CNL-17-100

Clinch River Nuclear Site
NRC Docket No. 52-047

Subject: Response to Request for Additional Information Number 5, Questions 02.05.01-03 and 02.05.01-05, Regarding Basis Geologic and Seismic Information in Support of Early Site Permit Application for Clinch River Nuclear Site

Enclosure 1
Response to NRC RAI Number 5, Question 02.05.01-03

Figure 2.5.1-87. Crystalline Calcite Deposits Indicating a Hypogene Origin in Caves of Shenandoah Valley, Virginia

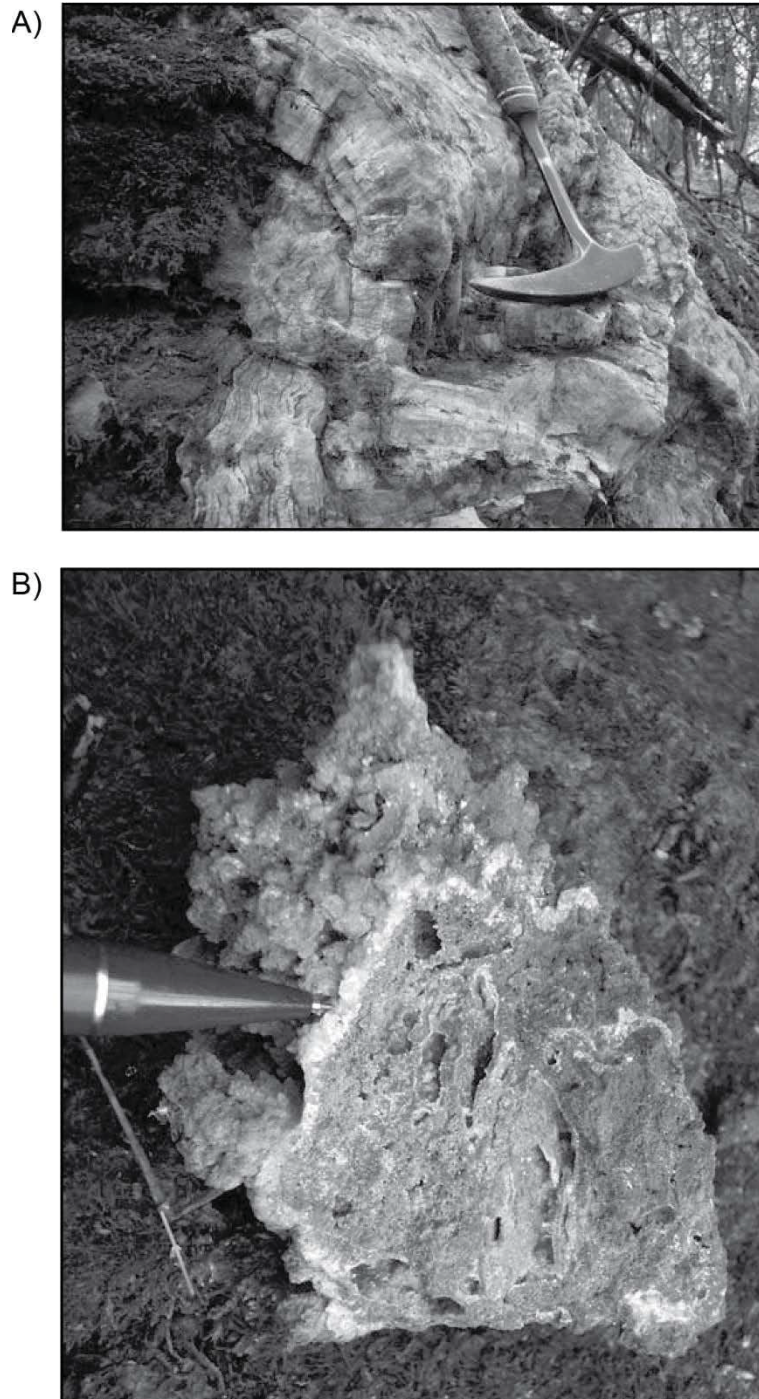
- b. The SSAR (Rev 0) 2.5.1.2.5.1 CRN site karst conceptual model indicates under item 9: "Evidence of hypogene processes is not documented at the CRN Site". The SSAR indicates that some deep phreatic groundwater circulation may be occurring in the Chickamauga carbonate rock beneath the ORR area, and dissolution conduits and cavities may be present to depths of more than 800 ft. (Reference 2.5.1-213, Ausich & Meyer, 1990). Although not discussed in the karst conceptual model, other sections of the SSAR have discussed other possible instances of hypogene karst systems in the area such as: Doll et al, reference 2.5.1-244, 2.5.1-245; TDEC hydrogeologists reference 2.5.1- 299; Nativ and others, reference 2.5.1-300 and 2.5.1-301; Wolf et al., 1997. Please provide a discussion of the potential for hypogene systems or features at the CRN site within TVA's conceptual model which also includes relevant information from these citations.*

Direct evidence of hypogene dissolution processes was not documented at the CRN Site or within the Oak Ridge Reservation (ORR). Most evidence is consistent with dissolution by epigenetic processes in the vadose and phreatic zones. This evidence includes the decrease in frequency of fractures and dissolution cavities with depth in boreholes (Reference 2), phreatic passage geometry and morphology of known caves and solution conduits within the ORR (References 3 through 5), and the lack of secondary minerals characteristic of hypogene processes. Springs in the ORR have water chemistry and temperatures typical of meteoric water (References 6 and 7), in contrast to the warm, mineral-rich waters of hypogene springs (Reference 8). Finally, seismic reflection profiles across the site show continuous, uninterrupted bedding at depth beneath the CRN Site suggesting that large hypogenic karst collapse features such as those documented in Biscayne Bay, Florida (References 9 and 10) are not present, at least along the two dimensional profile lines.

The major lines of evidence Doctor and Orndorff present for hypogene dissolution and deep phreatic dissolution of caves in the AGV are (1) the random landscape position of the caves, (2) the complex geometry of cave passages, (3) the presence of many thermal and travertine springs, and (4) the observation of cavities in water wells to depths of more than 1,000 ft. Caves appear to be randomly distributed beneath the landscape without regard for the modern stream networks. Cave elevations do not cluster about stream terrace elevations, nor do they cluster at any elevation that might reflect pauses in regional downcutting. Passages are not related to positions of modern trunk streams. Instead, cave passages are maze-like with vertical extents of over 20 m (76 ft). They follow joints, faults, and bedding planes, and have phreatic features such as cupolas and feeder tubes. Caves are known to occur in isolated hills with no inlets or outlets, far from base level streams. In an interview (Reference 2.5.1-298) and publication (Reference 2.5.1-319), Doctor also noted the presence of exotic mineral deposits, including dog-tooth spar, gypsum, iron, or fluorite, as evidence of hypogene processes (Figure 2.5.1-87). Present-day thermal and travertine springs indicate that hypogene conditions likely still exist at depth, and the presence of very deep dissolution cavities in water wells supports hypogene dissolution as an ongoing process. Figure 2.5.1-71 shows Doctor and Orndorff's (Reference 2.5.1-296) model of how the interaction of a fault and a fold can result in hypogene dissolution by waters rising along a fault.

New SSAR Figure 2.5.1-87 is added to SSAR Subsection 2.5.1:

Figure 2.5.1-88. (Sheet 2 of 2) Geologic Column and Cross Section of the 1983 CRBRP Excavations

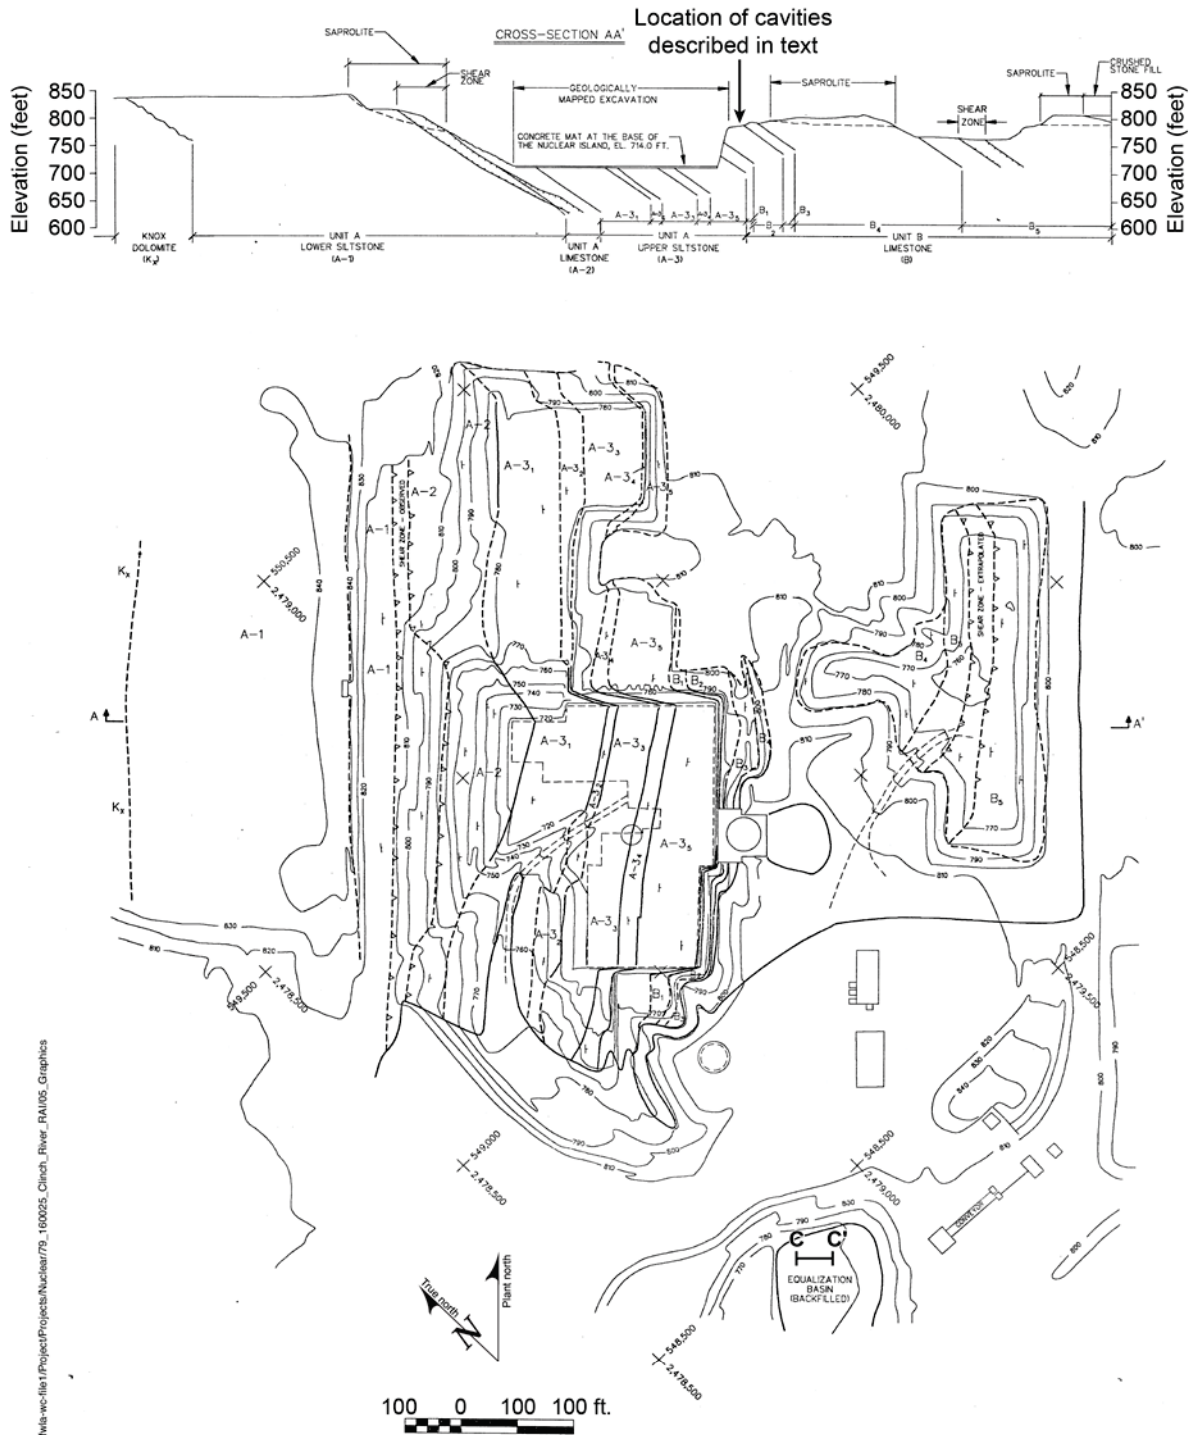
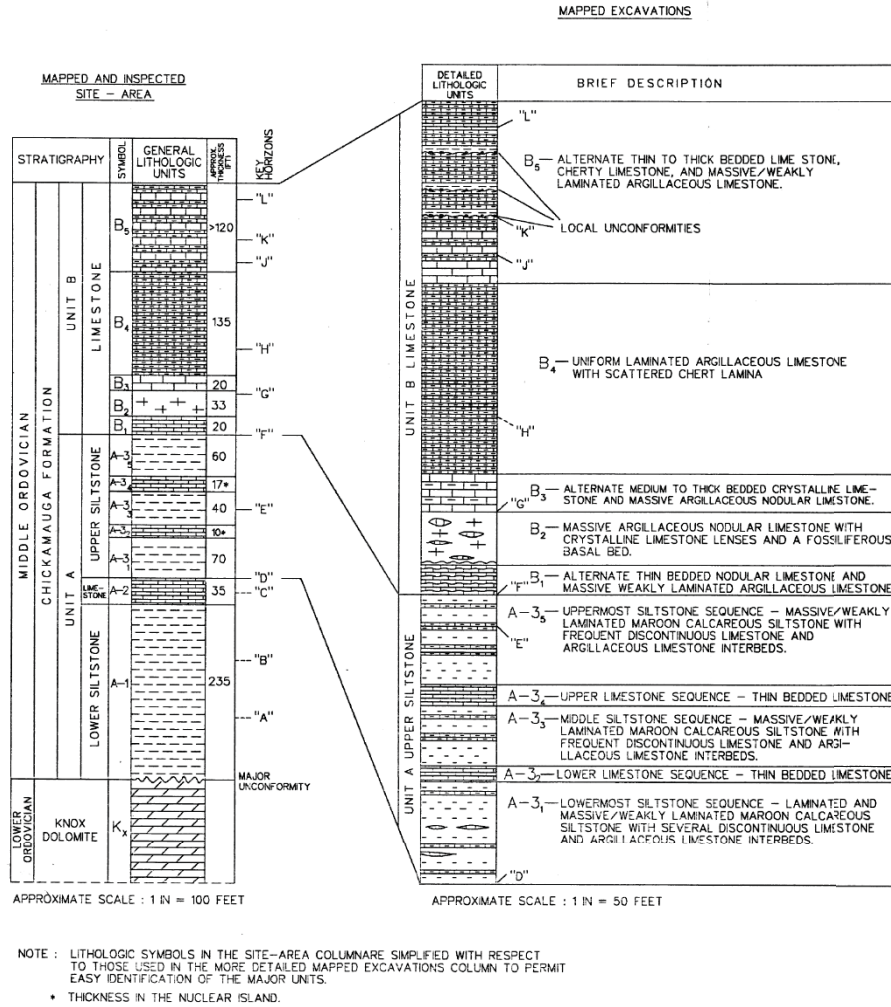
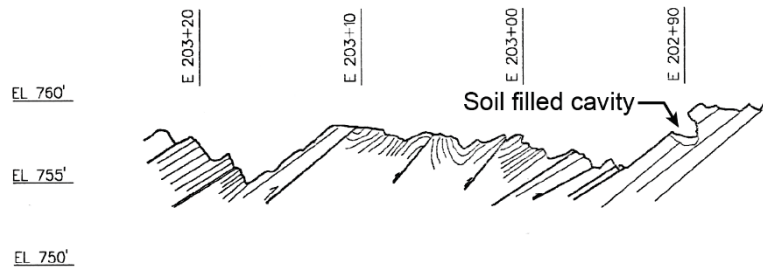
In addition, a discussion of geologic mapping of the excavation conducted in 1983 for the Clinch River Breeder Reactor Project (CRBRP) is being added as indicated in the SSAR markups below to SSAR Subsection 2.5.1.2.5.1.2 to aid in the understanding and assessment of karst hazards at the CRN Site. The excavation mapping was presented in a report by Drakulich (SSAR Reference 2.5.1-303). The excavation mapping report provides direct observations of weathering and karst features in the Fleanor member and Rockdell Formation. In the interest of providing a more complete assessment, a discussion of karst dissolution features exposed in the excavation, including illustrations excerpted from the report, is being added as indicated in the SSAR markup below in Subsection 2.5.1.2.5.1.2, "Karst Processes and Features at the Clinch River Nuclear Site," Subheading "*Karst Features in the CRBRP Excavation.*" The SSAR Subsection 2.5.1 markups reflect changes provided in TVA's letter CNL-16-162, "Submittal of Supplemental Information Related to Geologic Characterization Information, Surface Deformation and Stability of Subsurface Materials and Foundation in Support of Early Site Permit Application for Clinch River Nuclear Site," dated October 21, 2016. The SSAR markups will be incorporated in a future revision of the early site permit application.

The results of the CRBRP site investigation can be used to enhance and further inform the understanding of the geology and engineering suitability of the CRN Site. Excavations for the CRBRP were virtually complete before the project was cancelled in November of 1983. The excavations were mapped and described in detail prior to backfilling to provide documentation of the geology and structure exposed during the excavation (Reference 2.5.1-303) (Figure 2.5.1-88). Two excavations were made, a large excavation (480 ft long x 360 ft wide, and 100 ft deep) for the nuclear island (Figure 2.5.1-54) and a smaller excavation (180 ft x 180 ft shallow depth) for the Equalization Basin. The nuclear island excavation extended to an elevation of 712.5 ft MSL, with 75-ft-high near-vertical faces on the north, east, and south sides, and a 26-degree slope on the west side (References 2.5.1-100, 2.5.1-246, and 2.5.1-257).

The nuclear island excavation exposed the Fleanor member, a dusky red, shaley, calcareous siltstone with thin interbeds of limestone, over most of the walls and floor. The southeast wall exposed the Rockdell Formation. The Fleanor member exhibited deep chemical weathering of siltstone strata, with minor dissolution of its thin limestone interbeds (Reference 2.5.1-303). The siltstone was fresh at the base of the excavation, but found prone to slaking and disintegration upon exposure to weathering. Joints in the weathered zone at the top of the excavation were open or clay filled, and became less frequent and tight with depth within the unweathered rock. Similarly, the frequency and the extent of dissolution features were found to decrease with depth.

New SSAR Figure 2.5.1-88 is added to SSAR 2.5.1:
